INTER-OFFICE MEMORANDUM

**SUBJECT:** DRC Meeting Date: August 3, 2010  
Preliminary Plat Application  
Project Name: Sunrise Cove  
Project Number: 2009-S-PPL-0249  
RSN: 670451

**TECHNICAL REVIEW COMMITTEE COMMENTS**

**July 28, 2010**  
**Sunrise Cove**  
**2009-S-PPL-0249**

SHEET 2 OF 7

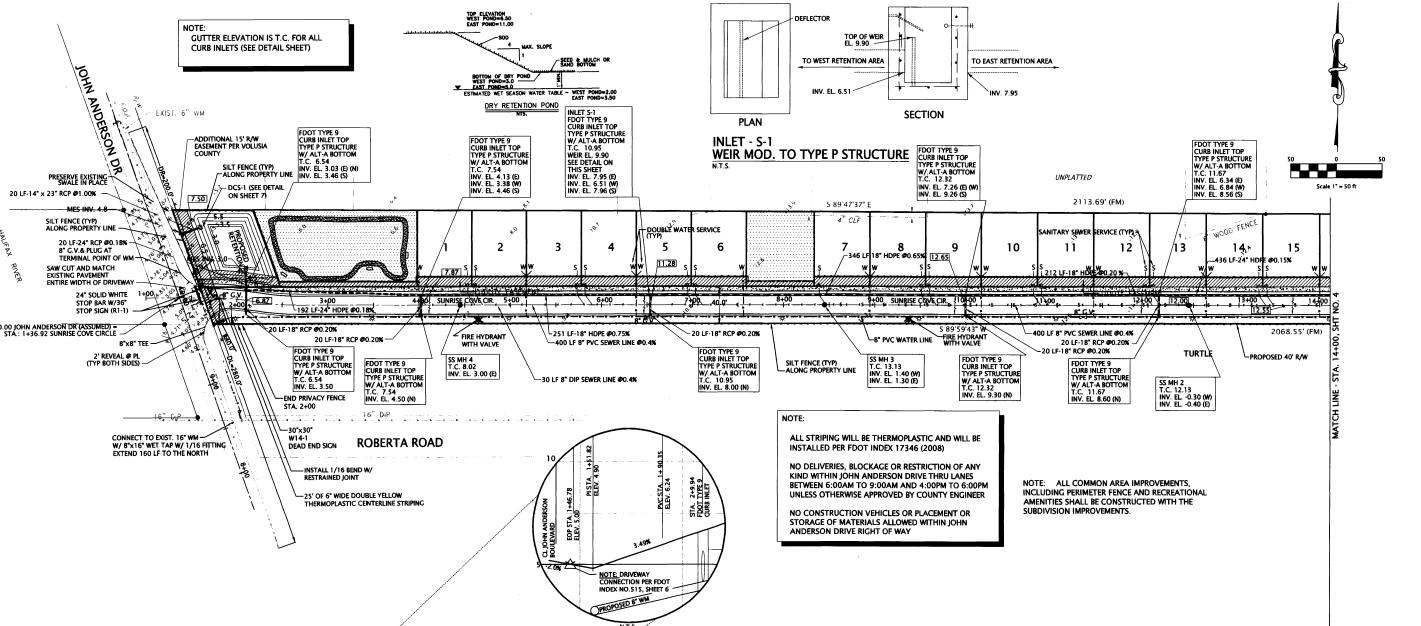
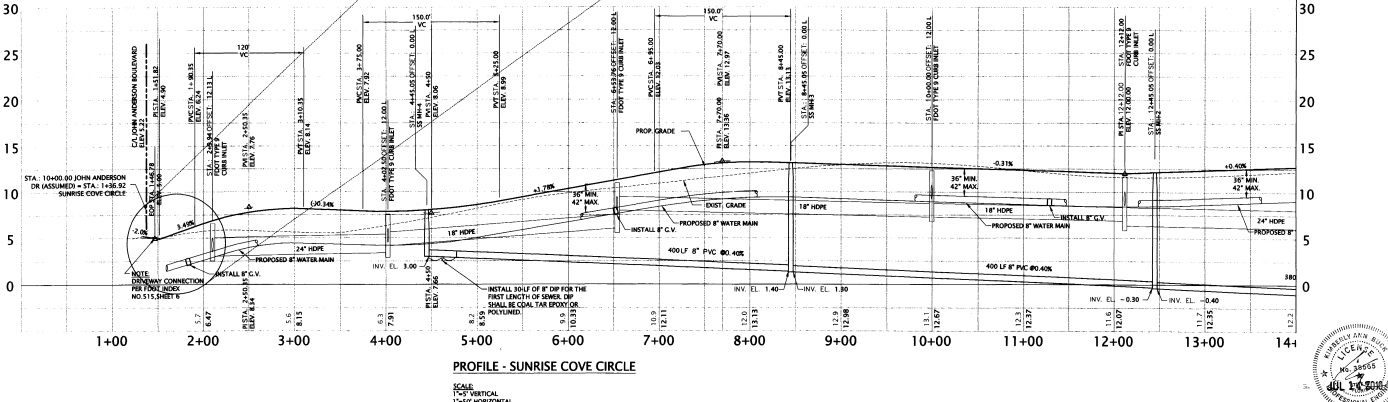
1. The pond does not appear to have been enlarged - please clarify the use of voids in the soil as storage. The maintenance of these ponds should remain private due to the high maintenance required due to low/no compaction of the soils.
2. John Anderson has difficult drainage, provide details of the outfall path from the pond to John Anderson to the river.
3. Provide fabric under the proposed rip-rap, section C-C sheet 3 of 7.
4. Provide details of Inlet S-1 with weir, see sheet 2 of 7. Maintenance concerns: provide dimensions/materials details.
